ADDENDUM No. 1

ITB No. 4556

2019 Miscellaneous Utility Project

TRENCH DETAIL - TYPE I, SD-TD-1, MODIFIED

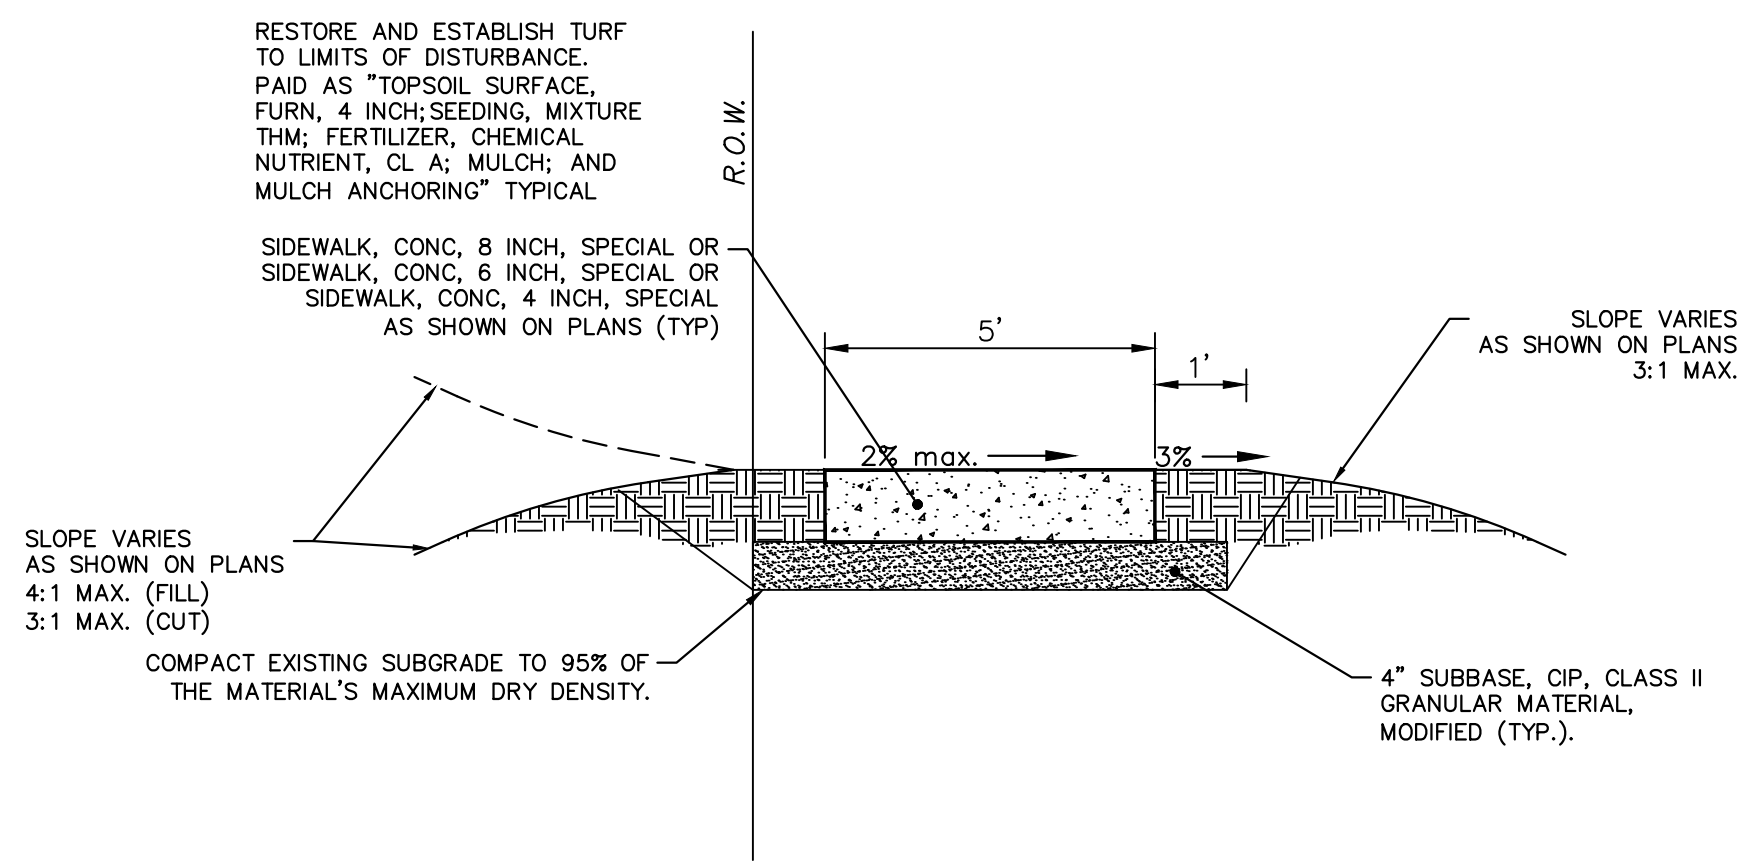
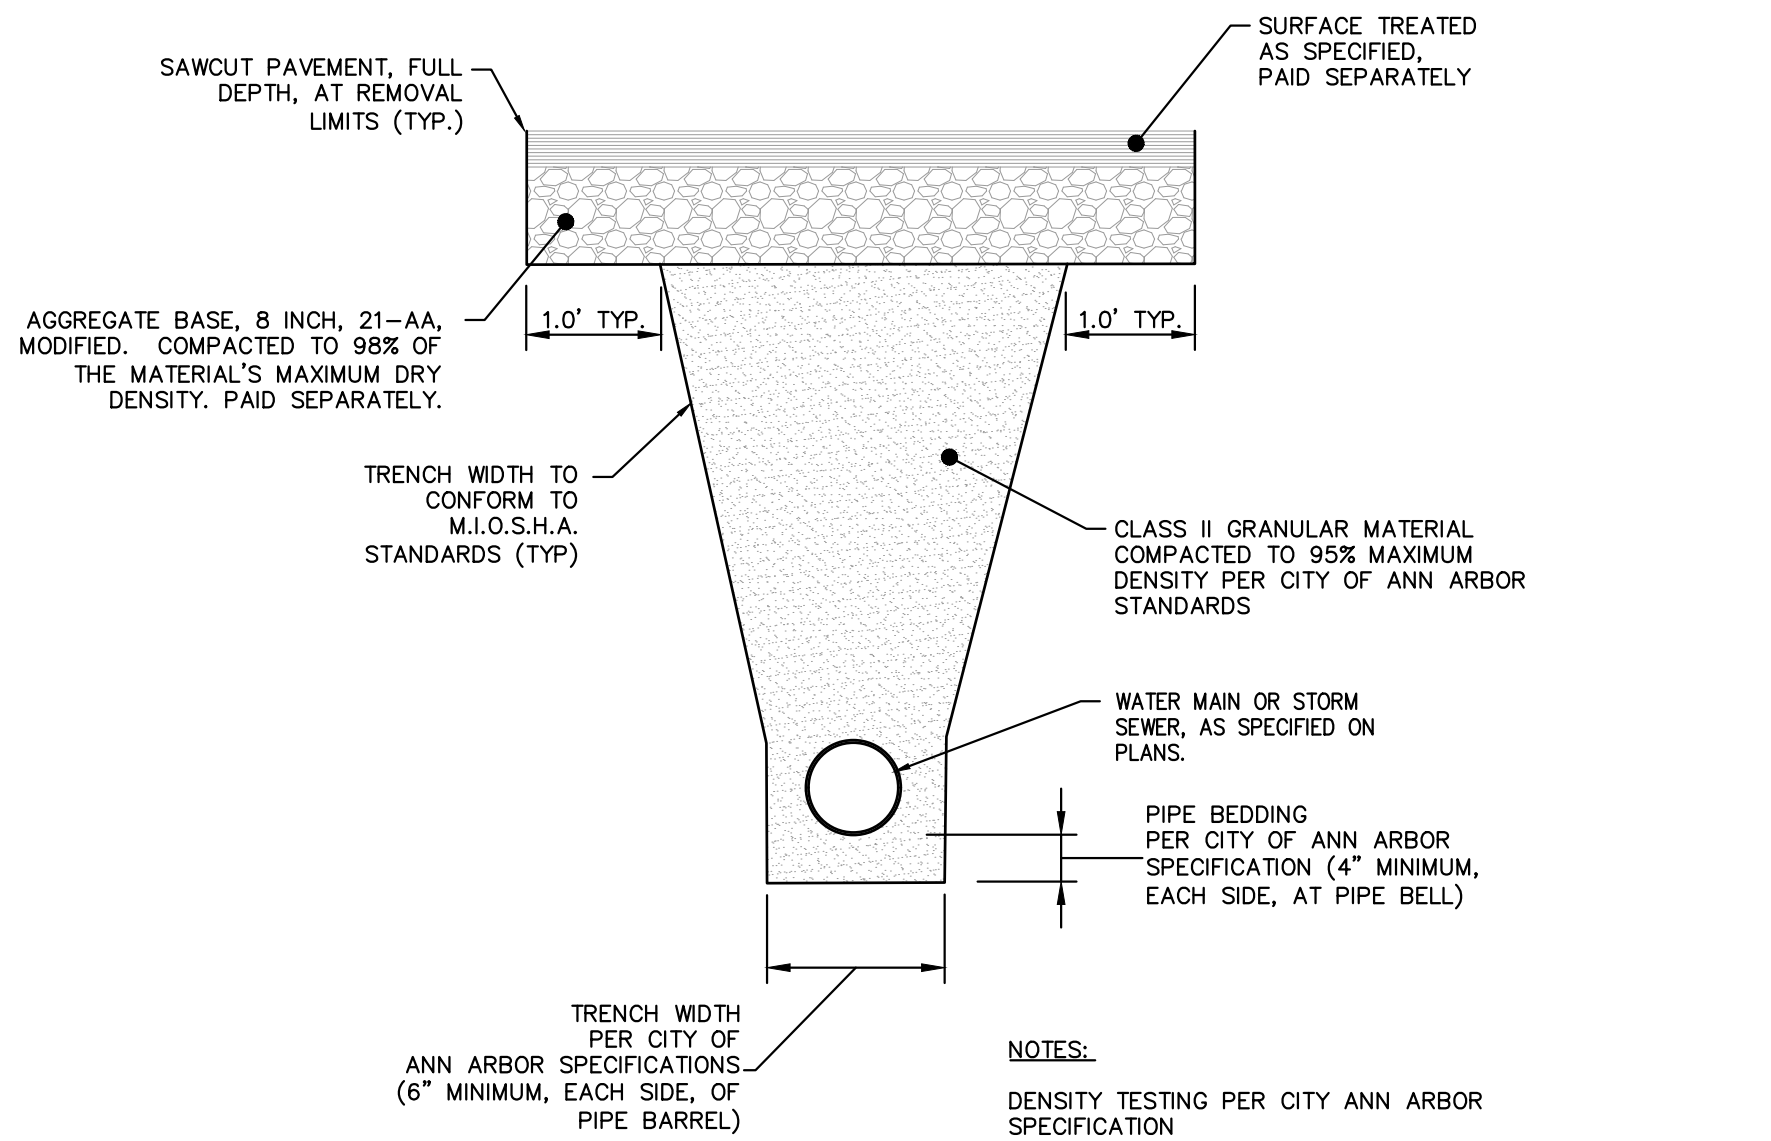
Plan Sheets 5 was updated to remove Trench Detail Type II. Trench Detail Type I remains on Sheet 5 and states the surface treatment will be paid for separately. As shown on the detail, Class II granular backfill is to be included in the cost of the pipe. A standard sidewalk detail was also added to this sheet.

CITY OF ANN ARBOR
MICHIGAN
2019 MISC UTILITY PROJECTS
TYPICAL SECTIONS
BUCHOLZ COURT

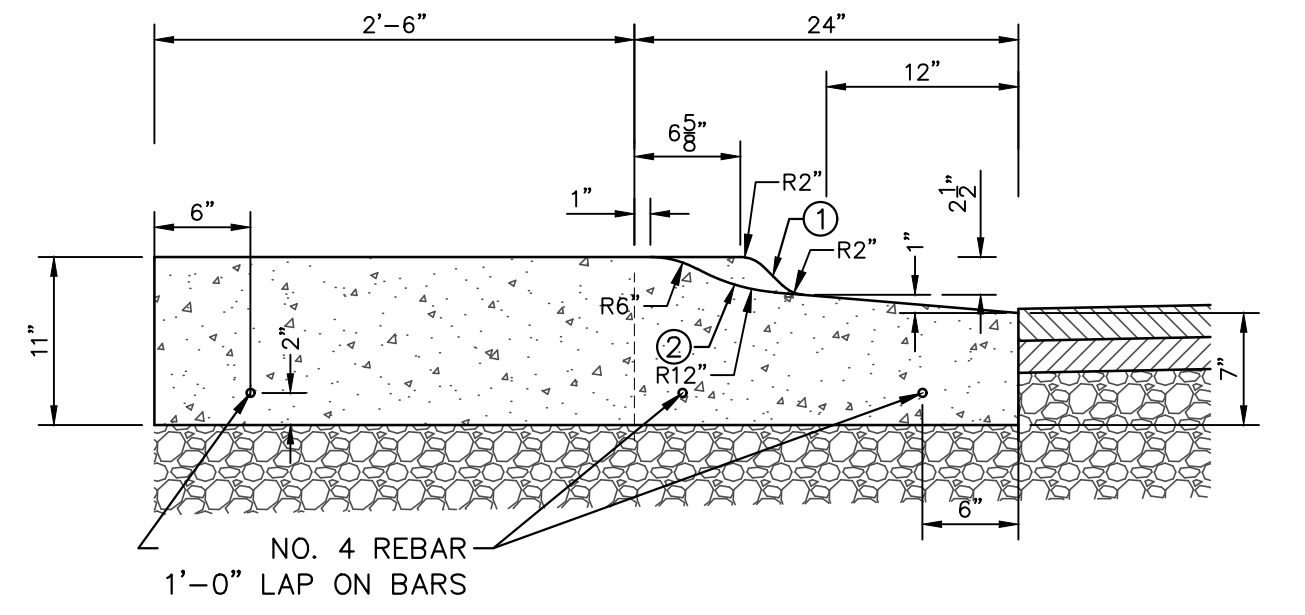
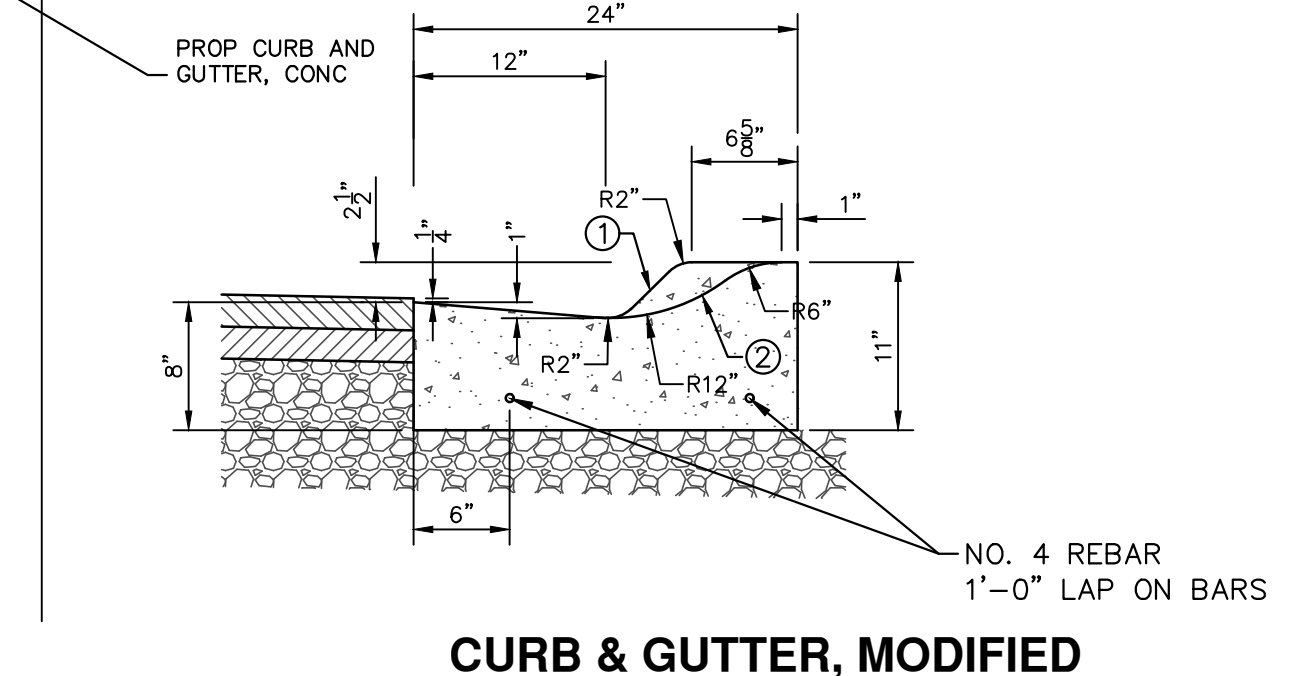
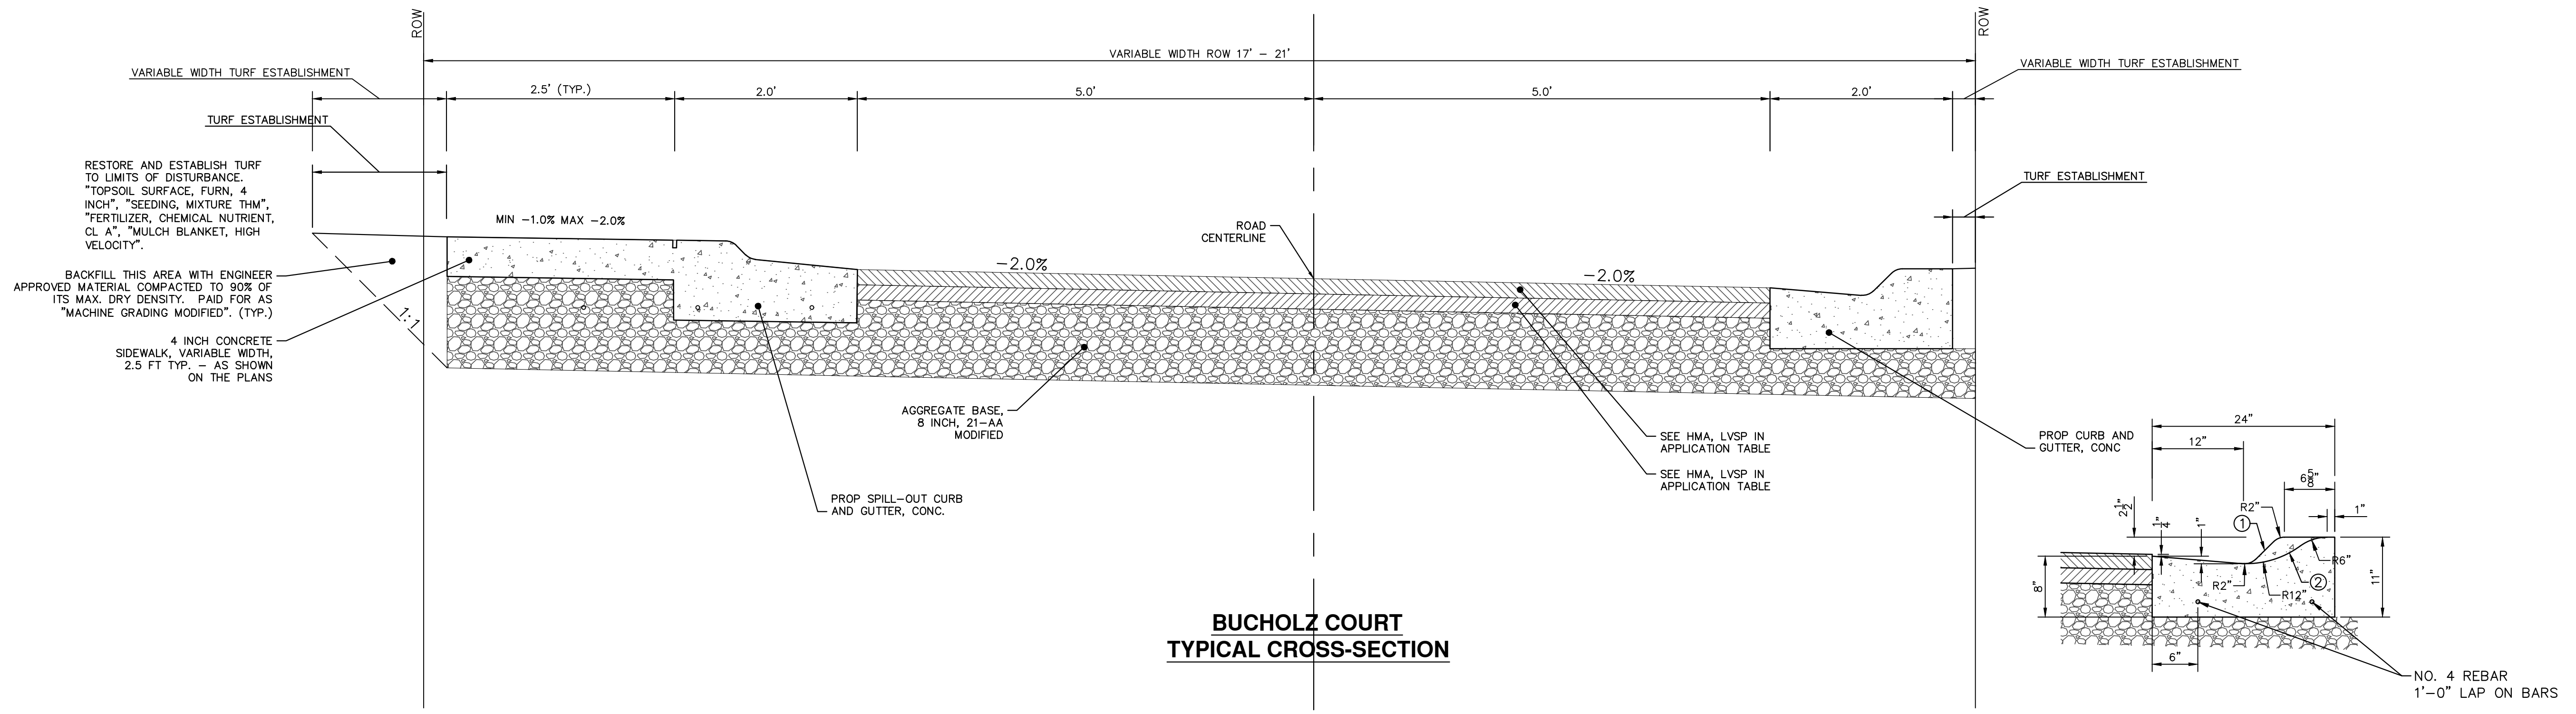
Plan Sheet 6 was updated with a modified curb detail for Bucholz Ct.

Plan Sheets 6-8 were updated to clarify the pay items and construction methods being used in the Cross-Sections.

**CEDAR BEND DRIVE
PROPOSED PAVED CROSS-SECTION**

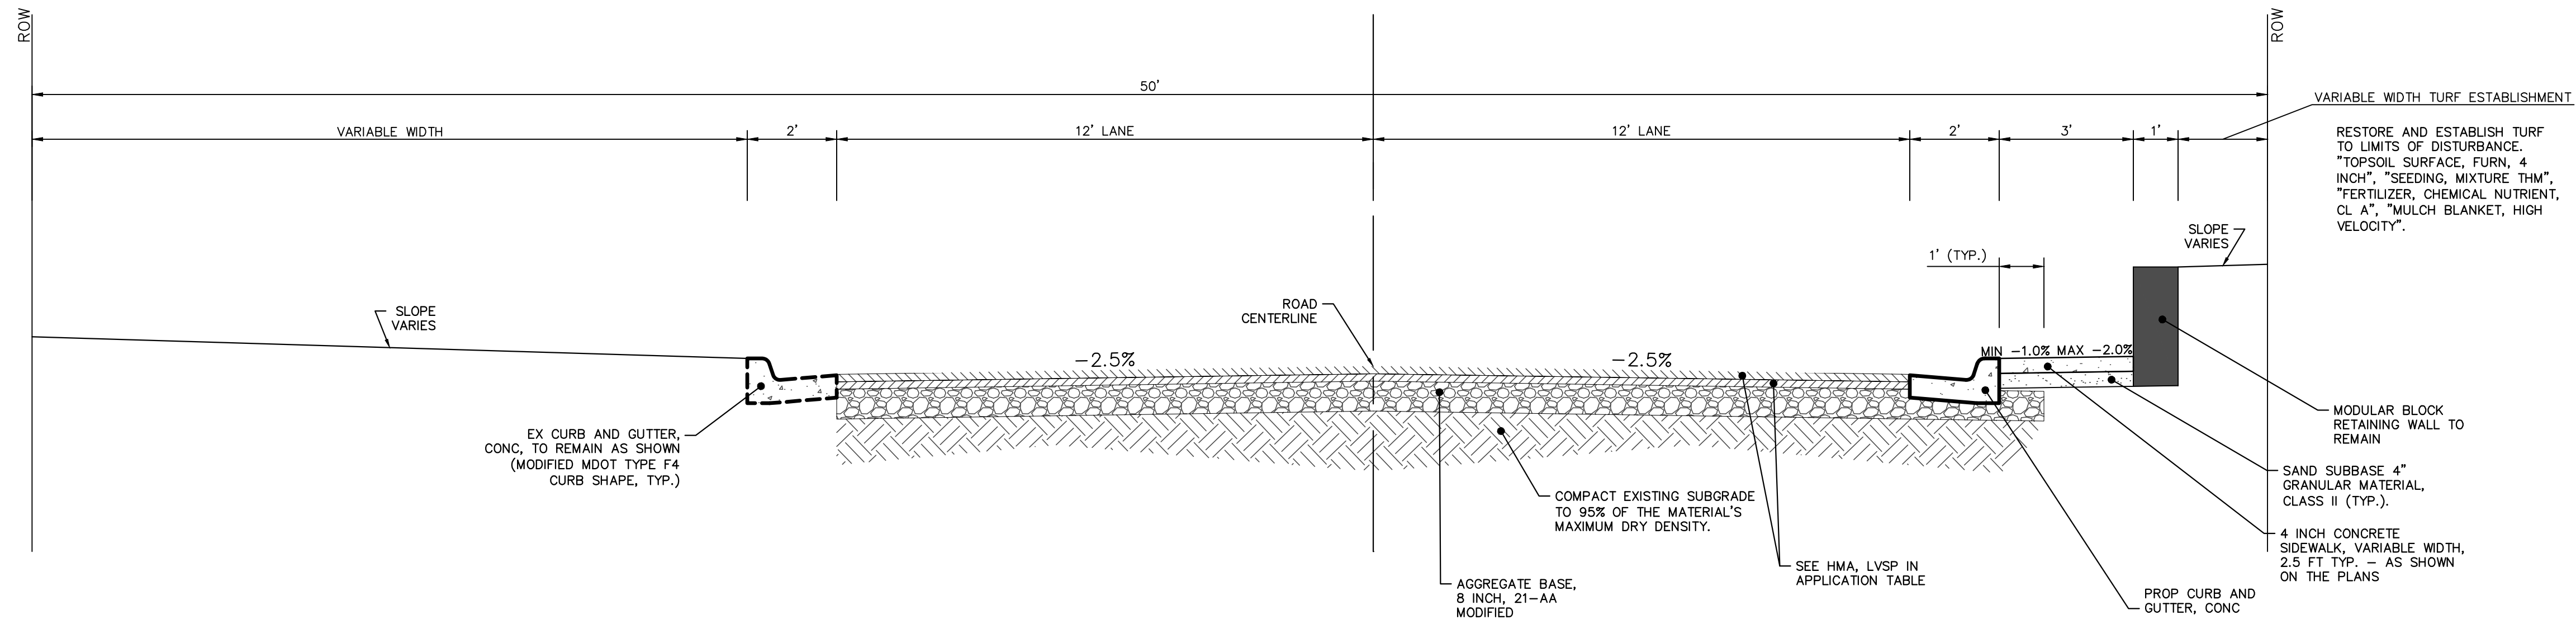
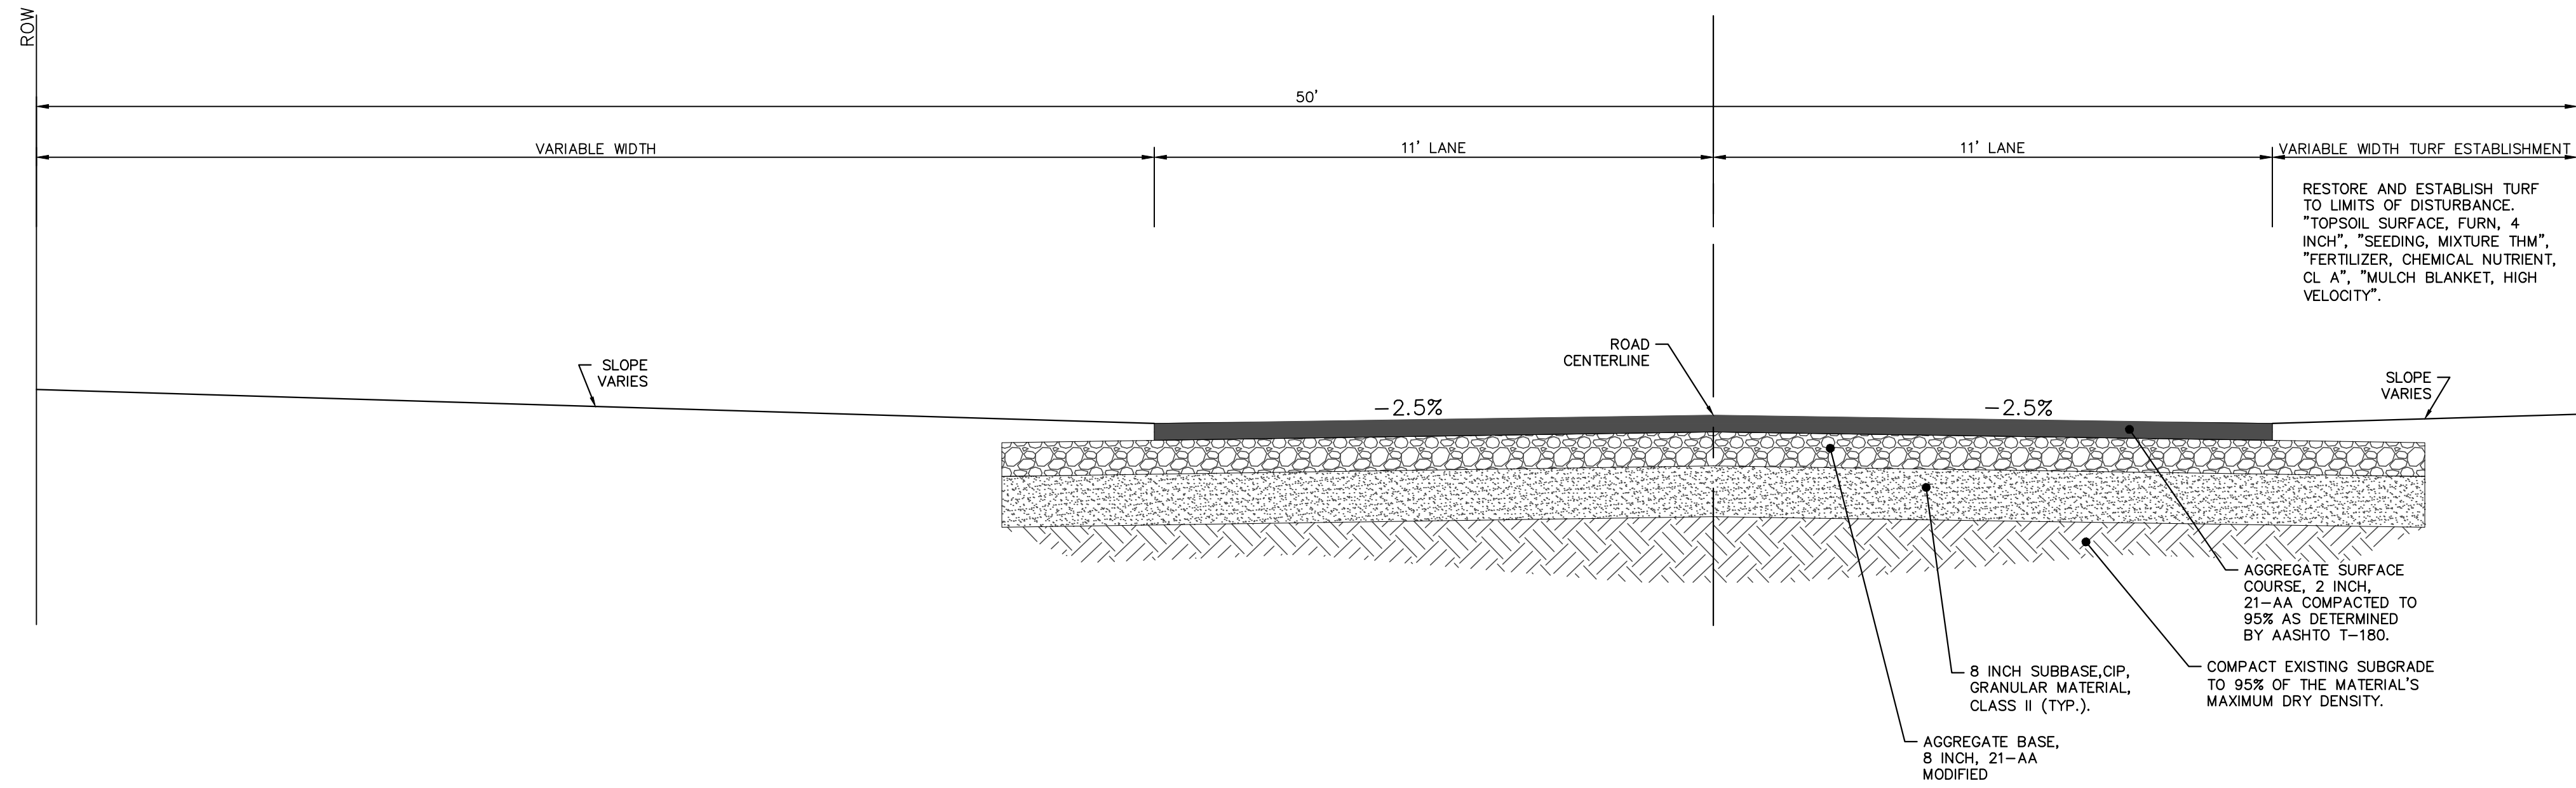
The Detailed Specification was updated to clarify that the aggregate surface course for the proposed gravel road on Cedar Bend will be 21AA, all references to 22A were removed from the document
